## **Approved - Proposed Elevation C** (*NE Facing*) Scale 1:100

с	Ame	nd following planning n	CG	07.09.2023					
В	Wind	dows revised to compy	SCB	12.01.2023					
А	Mate	erial confirmation from o	SCB	15.12.2022					
REV.	DET	AILS		INIT.	DATE				
TITLE	Conversion of Existing Barns to Residential,								
	Northdale Park, Raunds, Northampto						hire.		
DETAI	L	Elevation V	iew C;	1					
	Existing, Approved, Variation - Proposed.								
SCALE	Ξ	1:100	SHEET:	A1					
DRAW	/N	SCB	CHECKED		22-03	36-	152C		
DATE		December 2022	ISSUE	PRELIMINARY					
CONTRACTORS MUST CHECK ALL DIMENSIONS ON SITE, ONLY FIGURED DIMENSIONS ARE TO BE WORKED FROM DISCREPANCIES MUST BE REPORTED TO BLUEPRINT BEFORE PROCEEDING. © THIS DRAWING IS COPYRIGHT.

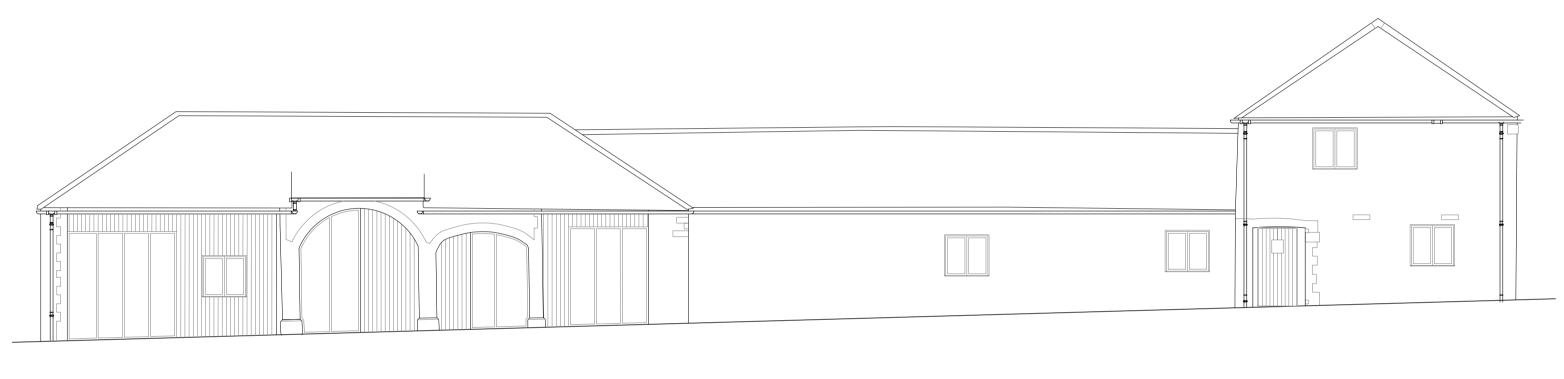
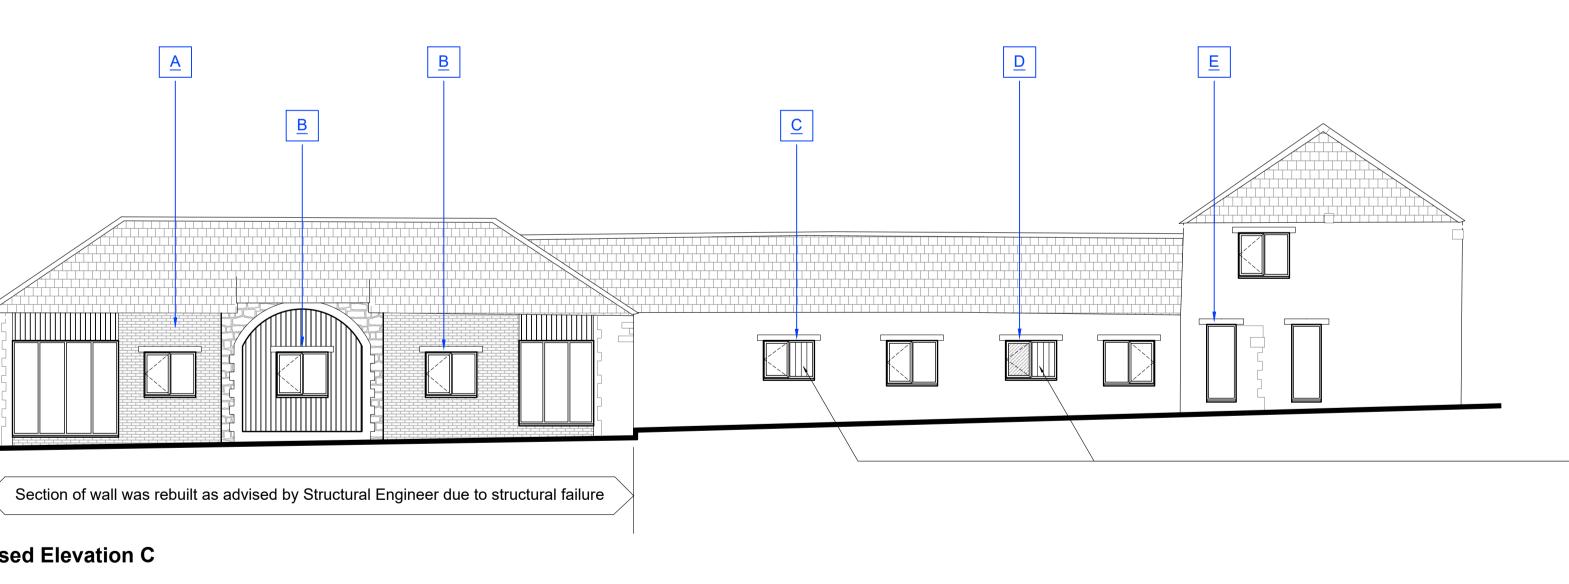
cent, the existing wall and arches are severely failing and will need nd approved materials have been proposed to preserve character of the	D	<u>Variation</u> - Additional window created. <u>Justification</u> - To serve Unit 6 En-Suite and provide natural ventilation and daylight.	
better balance glazing to room ratio within Unit 5.	Ē	<u>Variation</u> - Entrance door changed to full height fixed glazed panel. <u>Justification</u> - To improve security and privacy and keep all entrance doors along the same elevations.	
tilation into Unit 6 Kitchen area, due to other windows being full height fixed		Number of openings in wall on original approval = 10 Number of openings in wall on proposed application = 12
